JAMES A. FITZPATRICK NUCLEAR POWER PLANT

AMENDMENT TO FACILITY OPERATING LICENSE

Amendment No. 64
License No. DPR-59

SUPPORTING AMENDMENT NO. 64 TO FACILITY OPERATING LICENSE NO. DPR-59

FIGURE 3.1-2a
 Operating Limit MCPR Versus τ (Section 4.1.E)
 For 8x8 Fuel Types

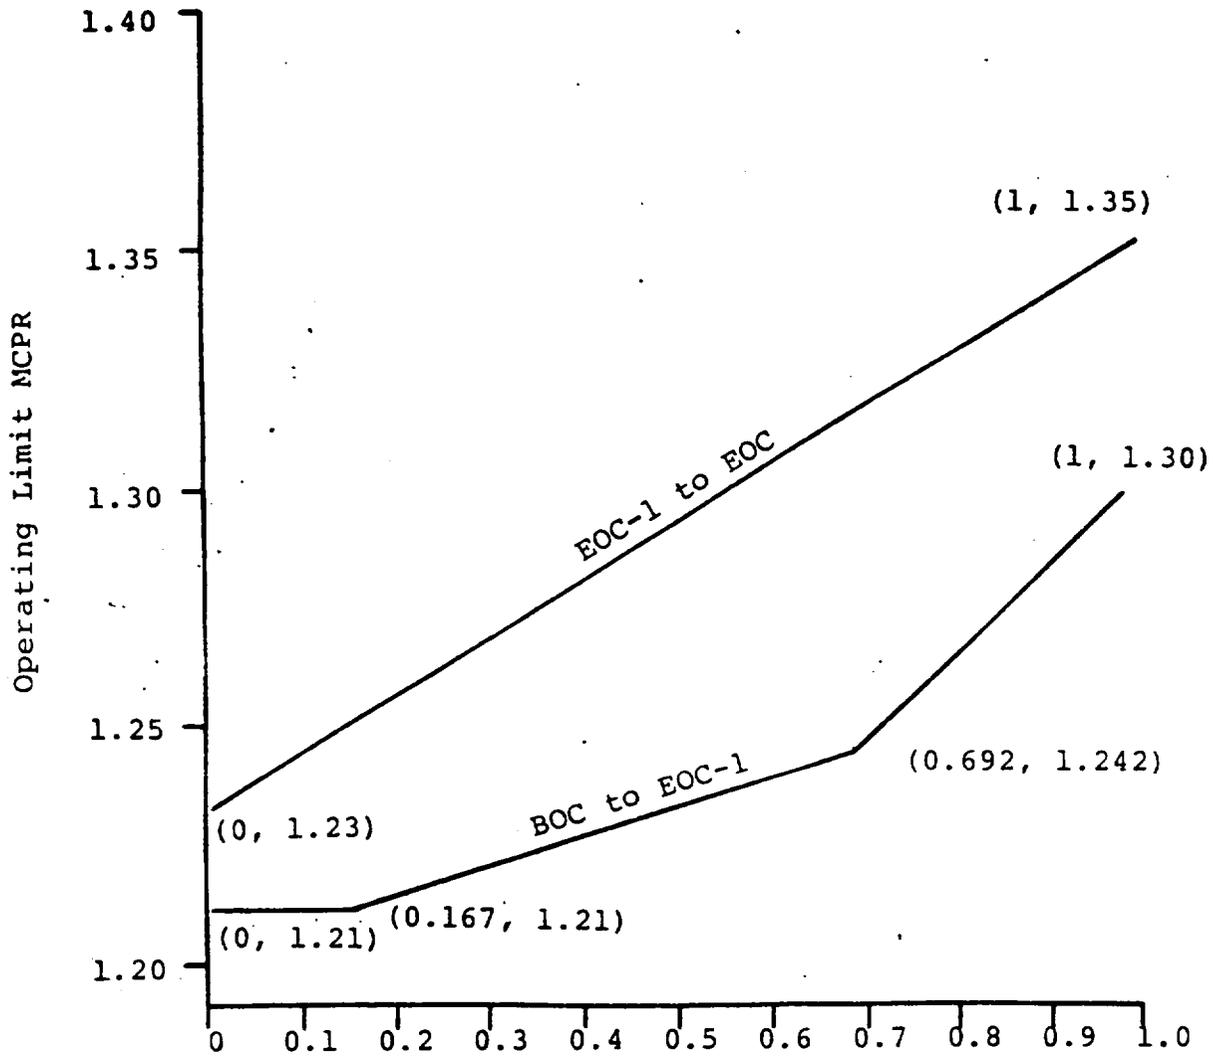
2. If requirement 4.1.E.1 is not met (i.e. $\tau_B < \tau_{AVE}$) then the Operating Limit MCPR values (as a function of τ) are as given in Figure 3.1-2a, 3.1-2b, 3.1-2c

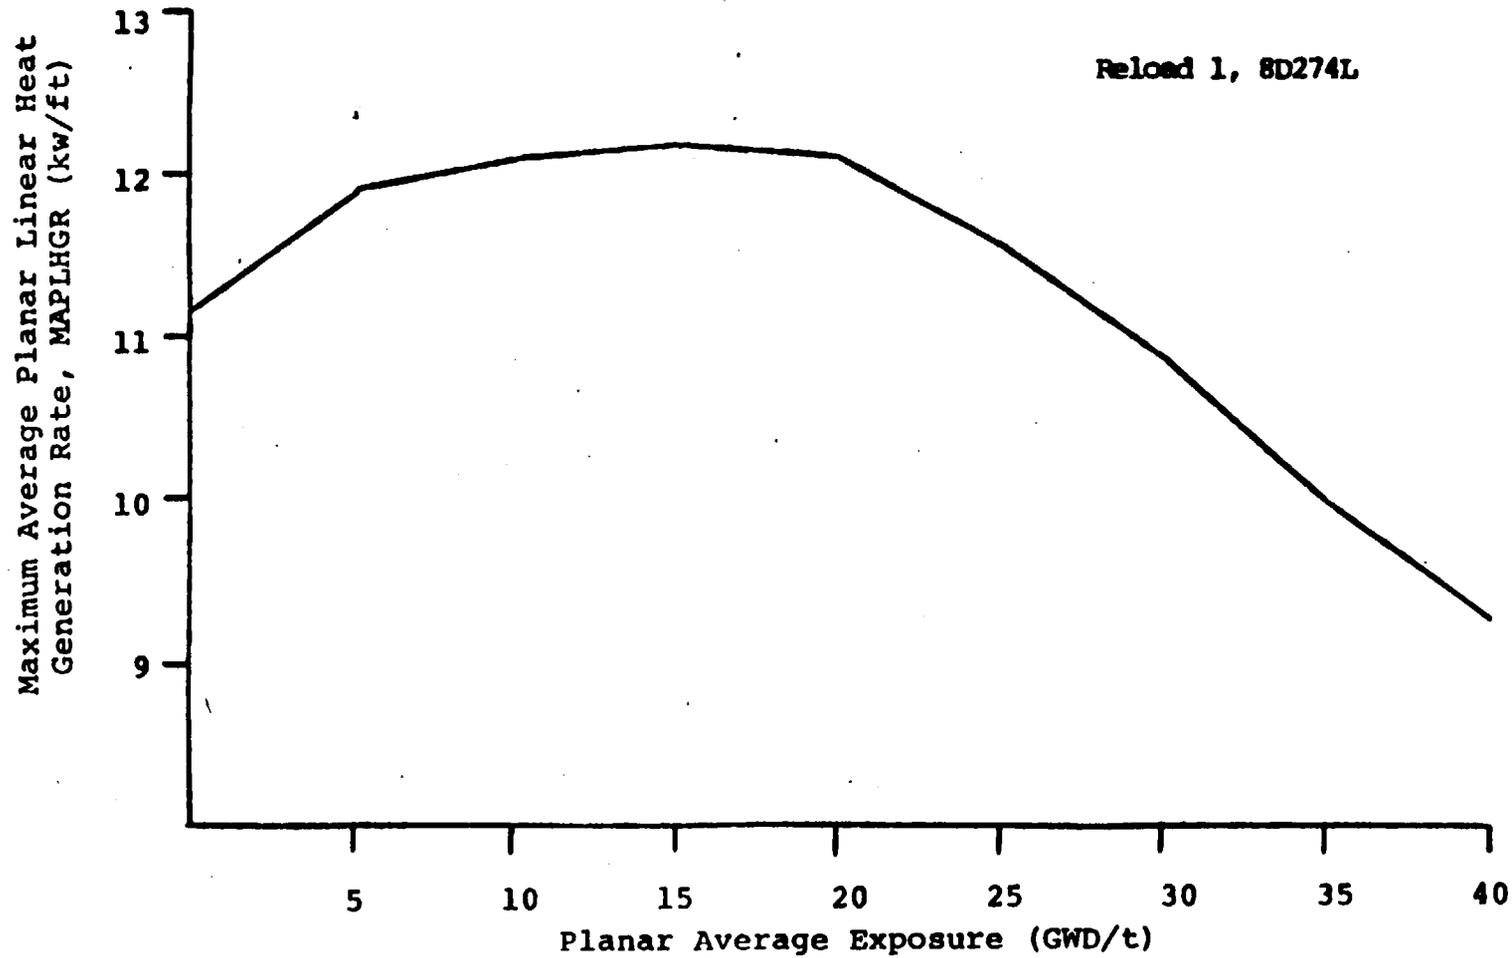
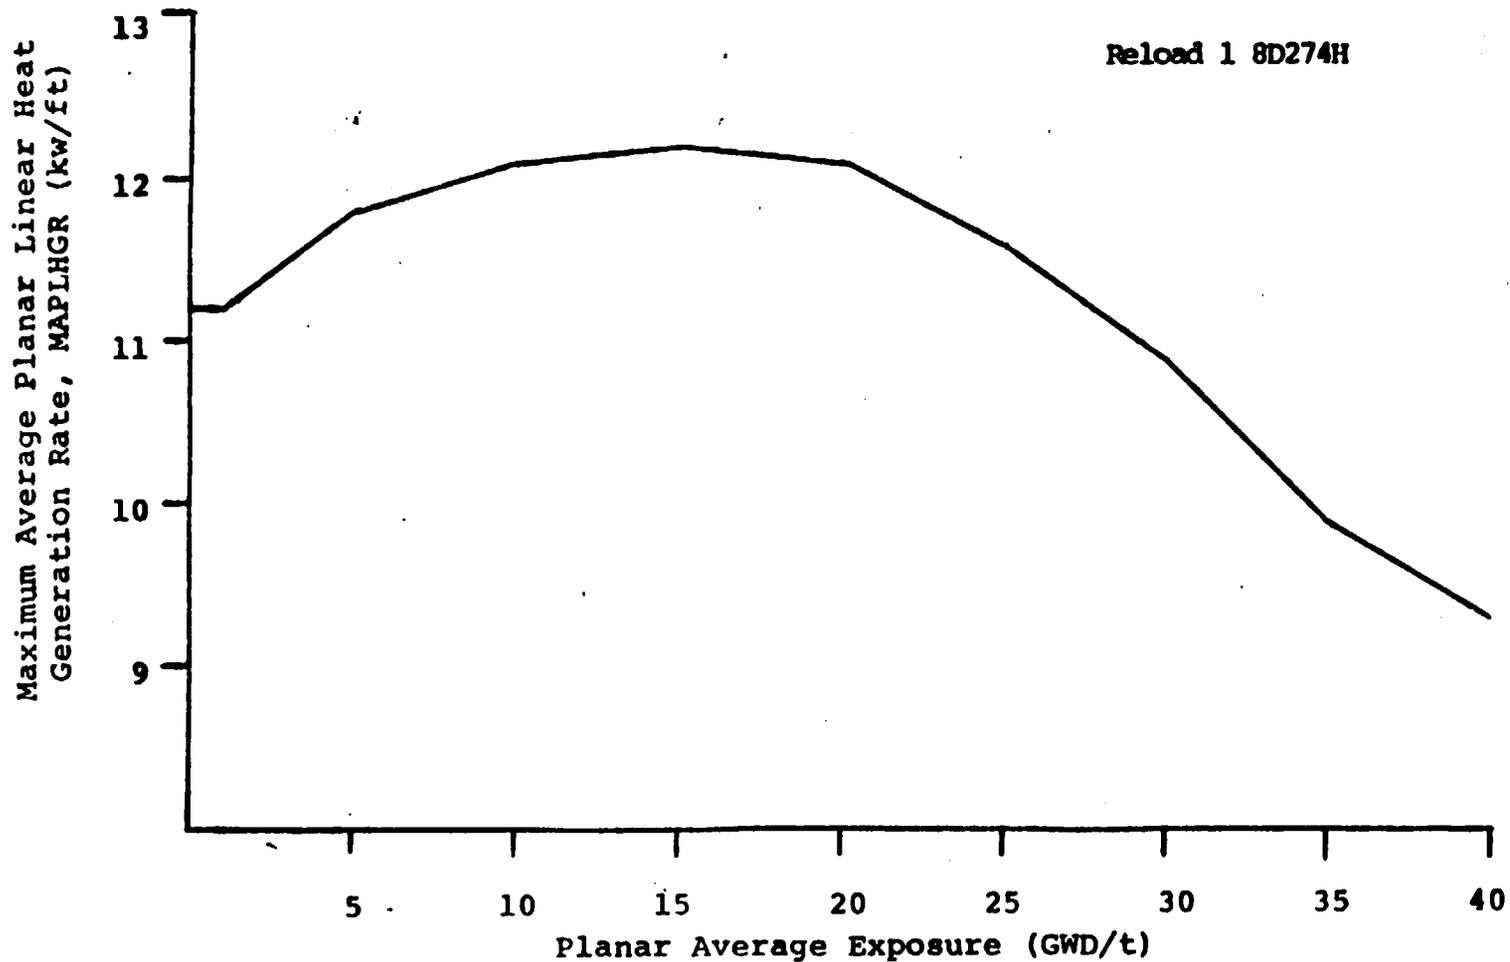
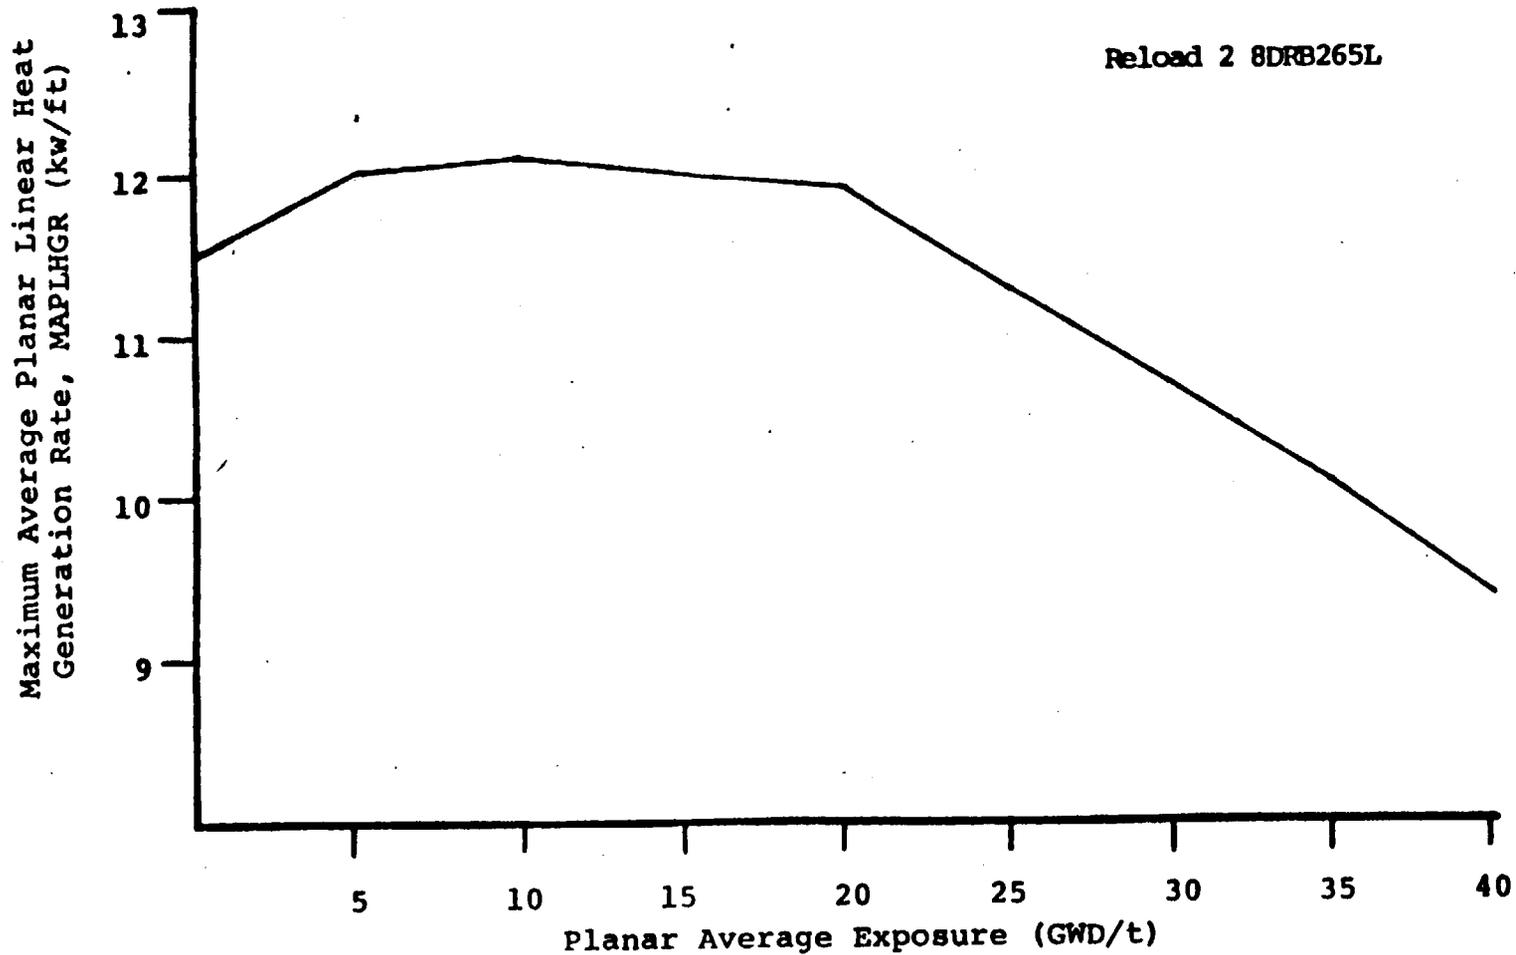
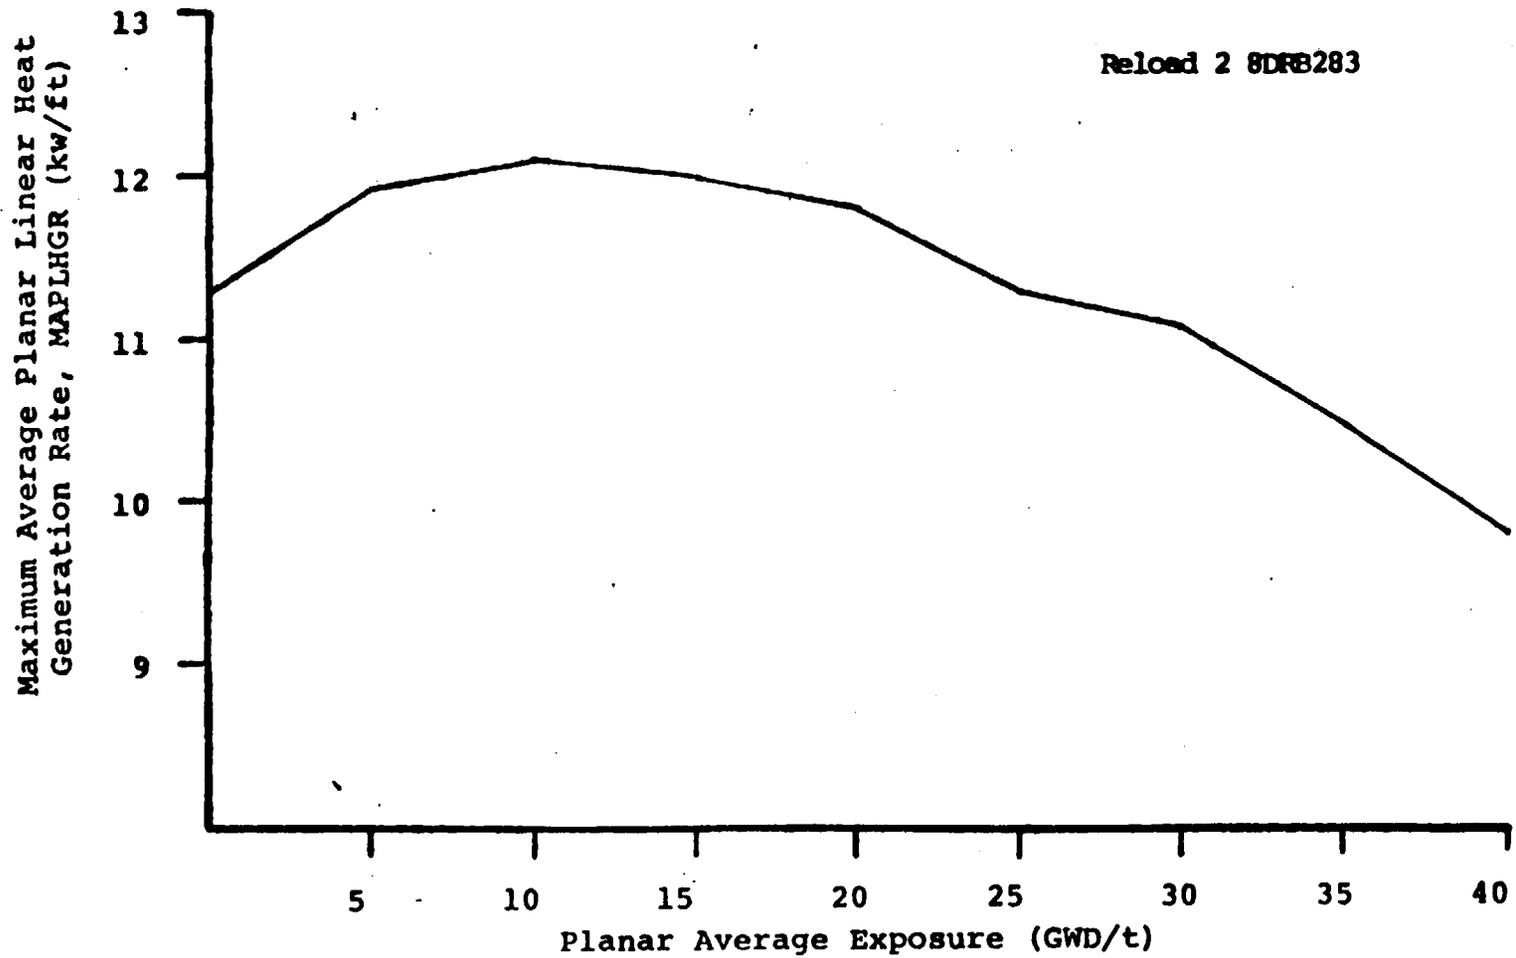
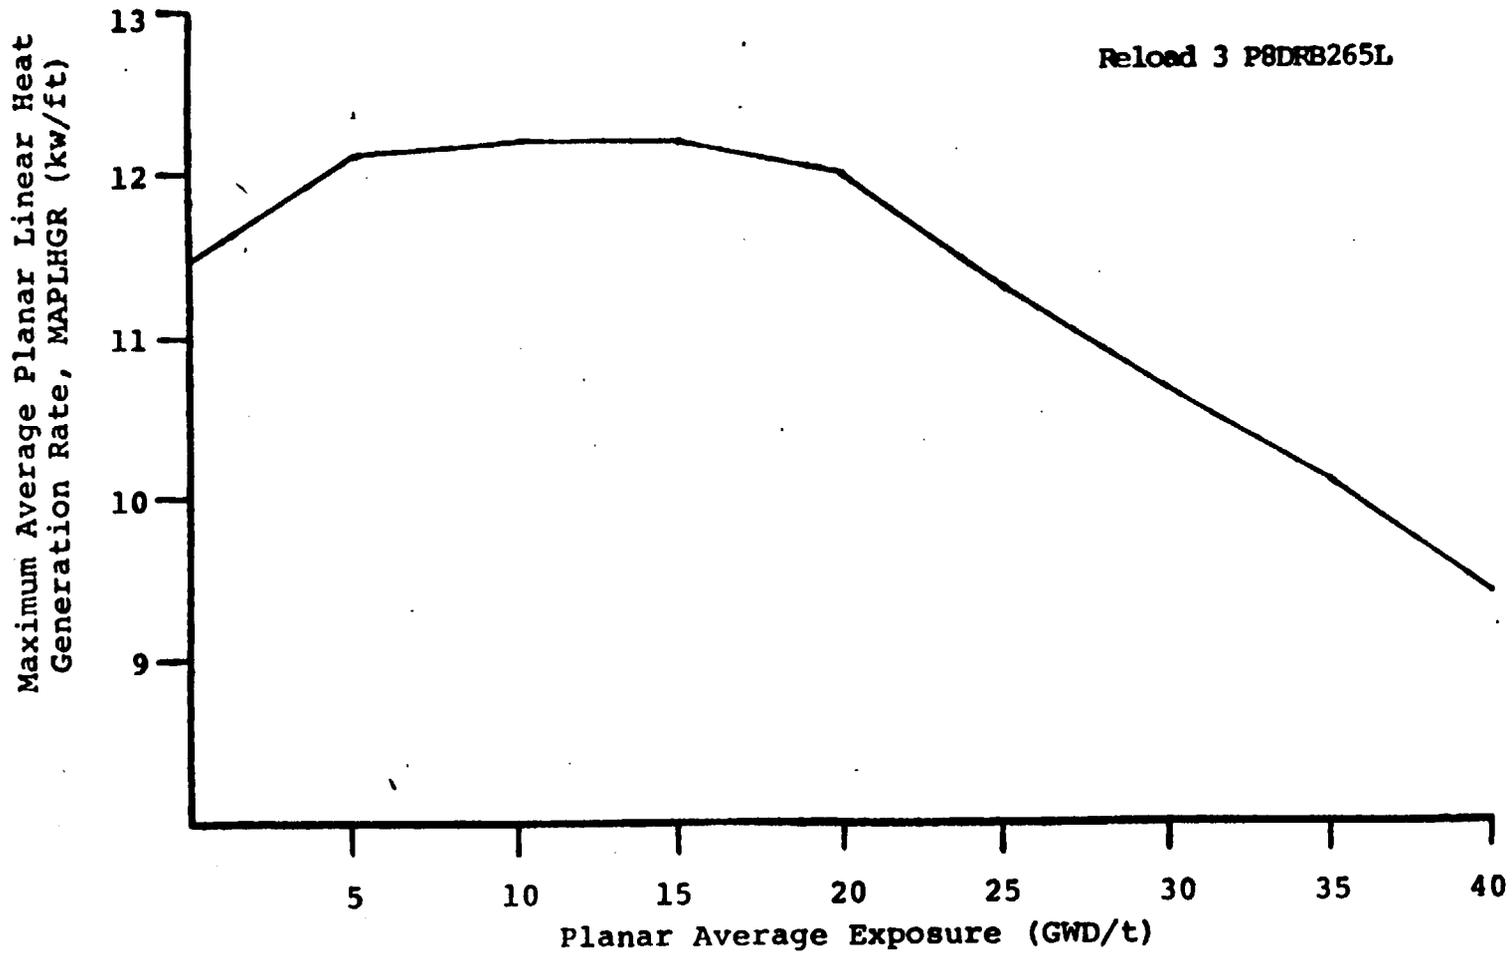
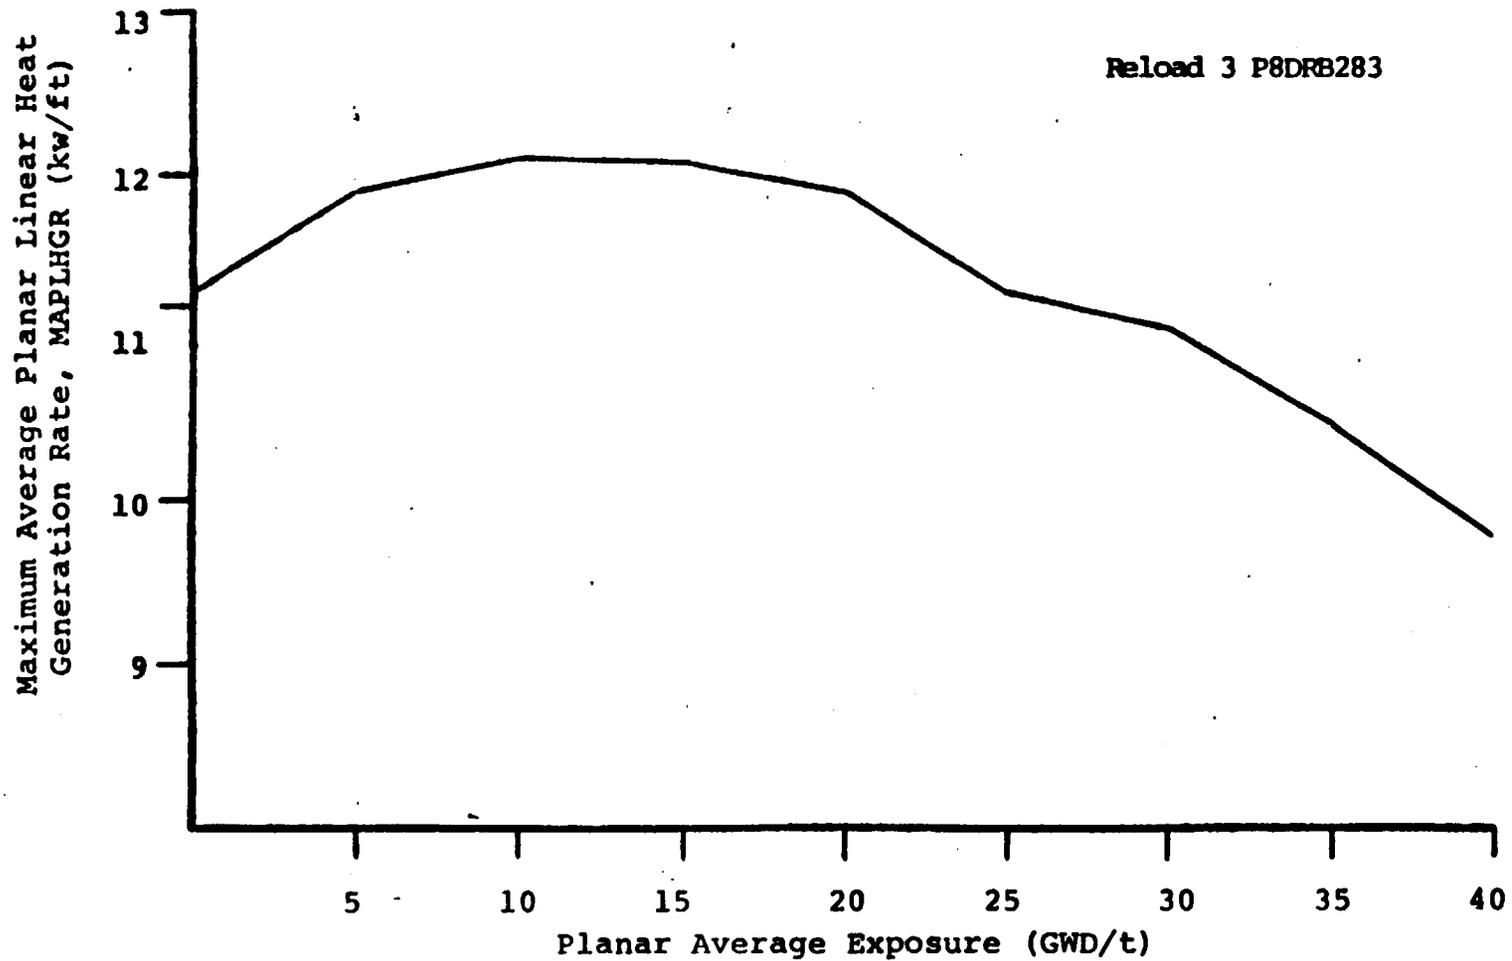
The APLHGR for each type of fuel as a function of average planar exposure shall not exceed the limiting value shown in Figures 3.5.3 through 3.5.10. If anytime during reactor power operation greater than 25% of rated power it is determined that the limiting value for APLHGR is being exceeded, action shall then be initiated within 15 minutes to restore operation to within the prescribed limits. If the APLHGR is not returned to within the prescribed limits within two (2) hours, an orderly reactor power reduction shall be commenced immediately. The reactor power shall be reduced to less than 25% of rated power within the next four hours, or until the APLHGR is returned to within the prescribed limits.

In References 7 and 8 GE requested that credit for calculated peak cladding temperature margin as well as credit for recently approved, but unapplied, ECCS evaluation model changes be used to offset any operating penalties due to high burnup fission gas release. This proposal was found acceptable (Ref. 9), provided the generic analysis was found to be applicable to each plant citing the GE position. In Attachment II of Reference 1 the licensee stated that the generic analysis is applicable to the FitzPatrick reload. On this basis we find the proposed Technical Specification changes (MAPLHGR limits) given in Attachment II of Reference 1 acceptable.
